ACT Planning System Review and Reform Project

Draft Inner South District Strategy

RE: Draft Inner South District Strategy – Section 19 Forrest.

Figure 38: Principles for Section 19 Forrest

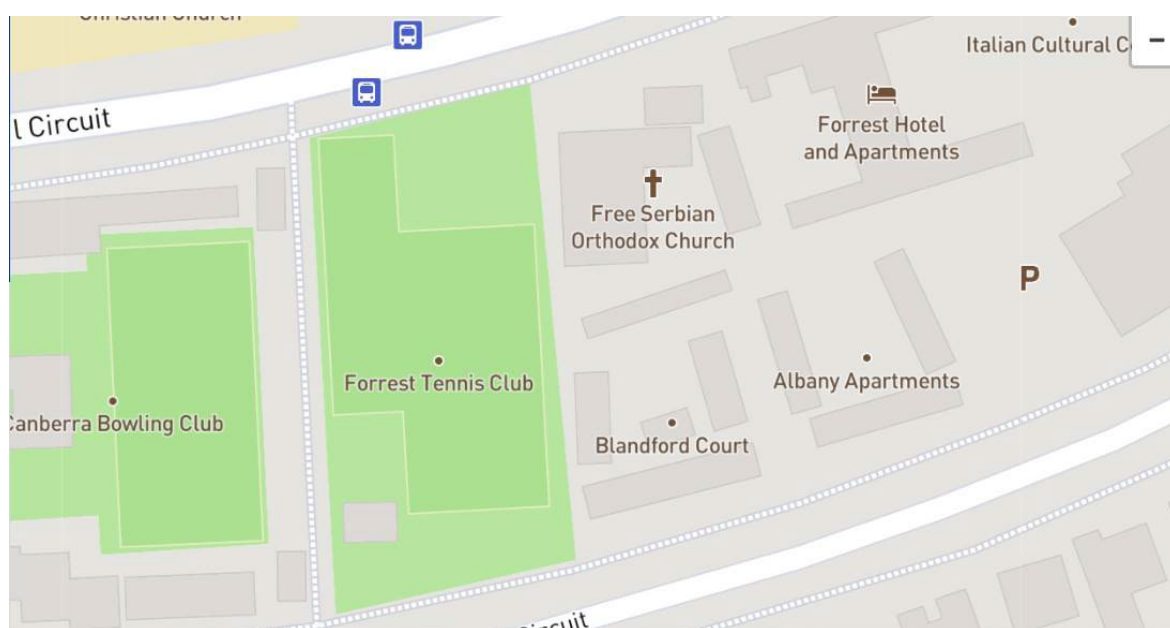
Firstly, it is noted that the Key principles are put forward to guide future planning and that they are conceptual only at this stage, put forward as early ideas for discussion. We note that there are numerous inaccuracies in the conceptual presentation, particularly in relation to existing driveway crossovers. For example, not all existing crossovers to Block 6 are shown and no driveway entry to Block 12 is shown at all. The inclusion of all driveway crossovers is important for CZ5 zoning to give planners and designers the best chance to design for all vehicles to enter and exit the site in a forward direction, for pedestrian safety above all other factors.

We request these inaccuracies be noted and corrected in future Strategic Plans and any inclusions in The Territory Plan.

The first of these is for the provision of a publicly accessible pedestrian path between Dominion Circuit and National Circuit. We refer to Figure 38 (above) from page 118 of the Draft Strategy. A possible linkage (labelled 1) is shown traversing the section, along the western boundary of Block 11 and continuing through the middle of Block 6.

We suggest that this link, as proposed by Principle 1 of the District Strategy, would serve very few people in relation to Section 19 and people living in the surrounding sections. This is based on destination potential, now and into the future, both north and south of Section 19.

Whilst the first part of the principle is reasonable, as it maintains and does not remove any existing property rights, it is noted that the diagram within the Draft Strategy does not correctly identify all of the existing driveway access points on all parcels. This should be rectified and clear where all existing access points are so that there is no ambiguity or misreading of the intent of the document when development under the new Territory Plan comes into play.

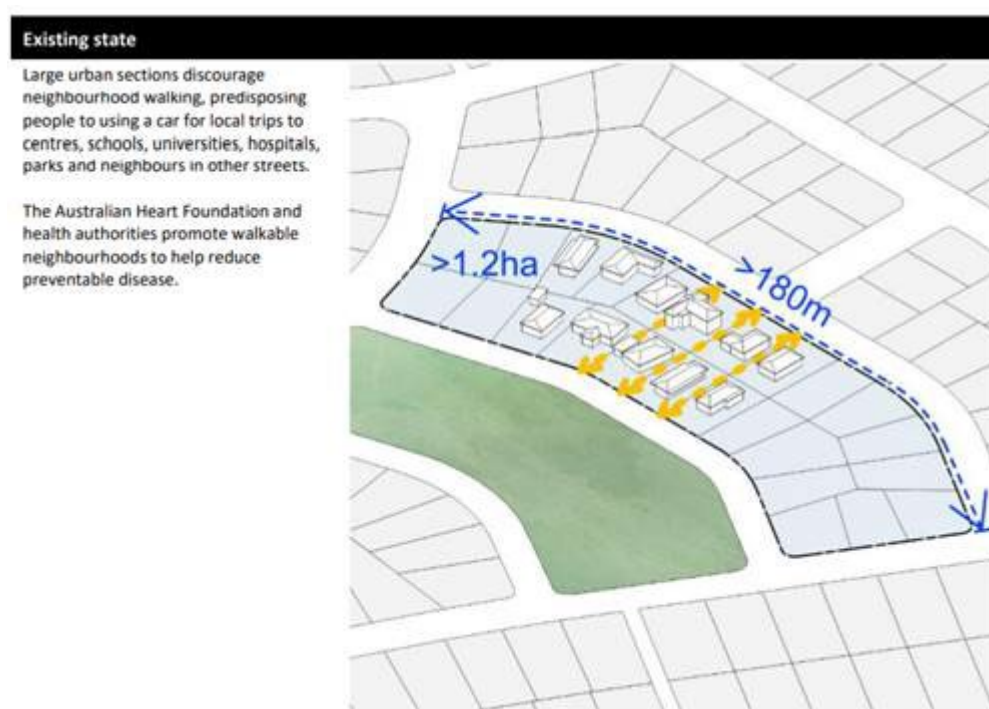
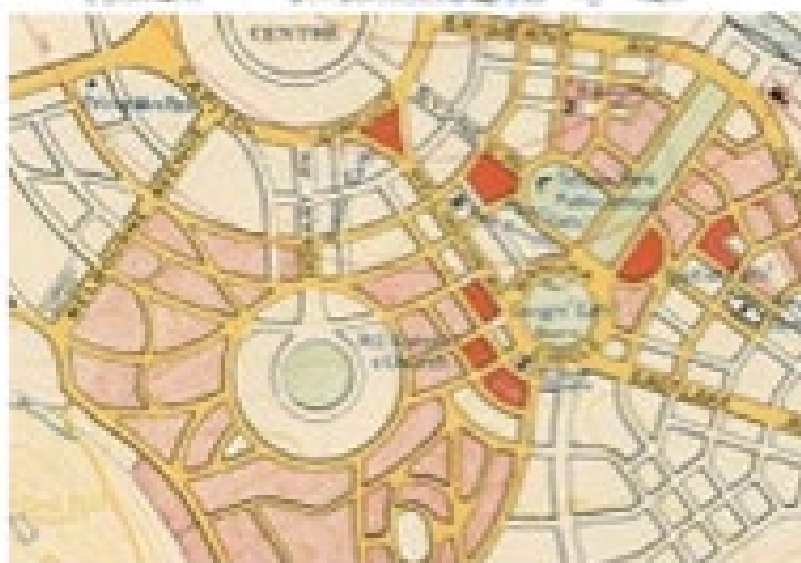
There is an existing walkway leading to the local school and two bus stops as shown in the Action bus map extract below. The publicly available pathway linkage connects National Circuit and Dominion Circuit (described as Block 10 Section 19) that lies between the Canberra Bowling Club and Forrest Tennis Club. This land is under the custodianship of City Presentation.

The distance between this existing walkway and Franklin Street to the east is 272 metres which exceeds the 180m desired by the strategy (as per the figure below and from page 140), however the proposed additional pedestrian connection does not connect to any existing transverse streets as shown in the Strategy illustration. Whereas the existing pathway connects pedestrians from Dominion Circuit and Arthur Circle to the school, the bus stops and the open oval opposite. We propose that Walter Burley Griffin got it right in their progressive refinements of their Canberra plan, and that the existing street and pathway arrangements around Section 19 neither discourage people from neighbourhood walking and offers sufficient useful connections to the public transport network.

'Urban improvement' approach

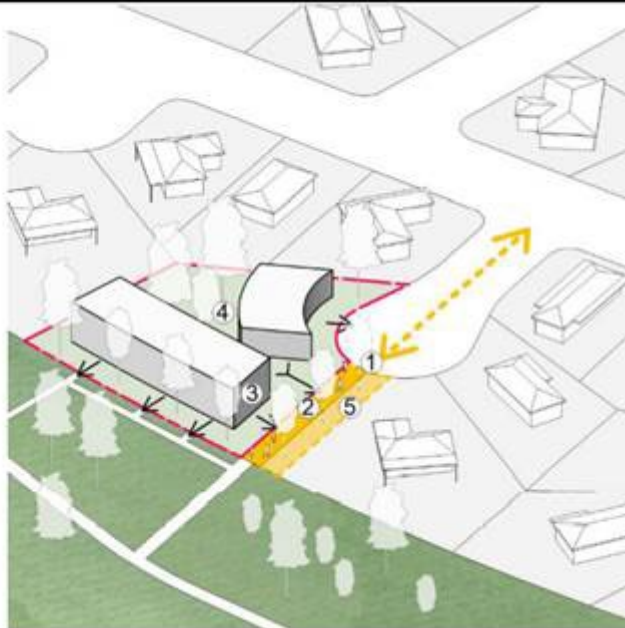
In light of the mooted CZ5 designation for Section 19 and increased population supported by that change, we consider a better response would be to not subsume parts of Blocks 6 and 11 in Section 19 to a new pathway connection, but rather to give them more direct access to the Manuka shops by affording a pedestrian connection through Section 20. We refer to the below figure from page 140 of the District Strategy which suggests urban improvement by adding pedestrian connections to link to existing streets. This suggested new link through Section 20 would allow the original Burley Griffin plan to better serve this growing city. Or perhaps it is better to leave the status quo in relation to pedestrian walkways and roads.

We also believe that a pathway on this alignment is not practical in the sense that to achieve a pathway along the indicated alignment would require the development of three separately owned parcels of land to occur in unison which is extremely unlikely. To propose to obtain access to land in an ad hoc manner, for future development of a pathway once all land came under the control of the ACT Government is fraught with risks and may not occur for a very long time as it is predicated on future development occurring. This could result in the government being left with ownership and management of a small dead-end strip of land, bounded by existing properties, for many years, that leads to nowhere, and becomes a burden to the community.

It is also not practical in the sense that, to obtain land for a pathway through Block 6 requires that this parcel be split into two non-contiguous parcels of land which severely affects future development potential.

To try and deliver a pathway that is practical from a land ownership sense would mean to realign the possible link to follow the existing property boundaries which would in affect create a pathway alignment that contains a zig zag bend midpoint creating numerous CPTED (Crime Prevention Through Environmental Design) concerns about safe use of the pathway. A pedestrian link of this configuration would have a high risk of making it unusable and completely ineffective because of surveillance and crime concerns. Producing a mid-section pathway that has no visibility from either roadways and creates blind corners and hiding spots would not comply with the ACT Government's own standards.
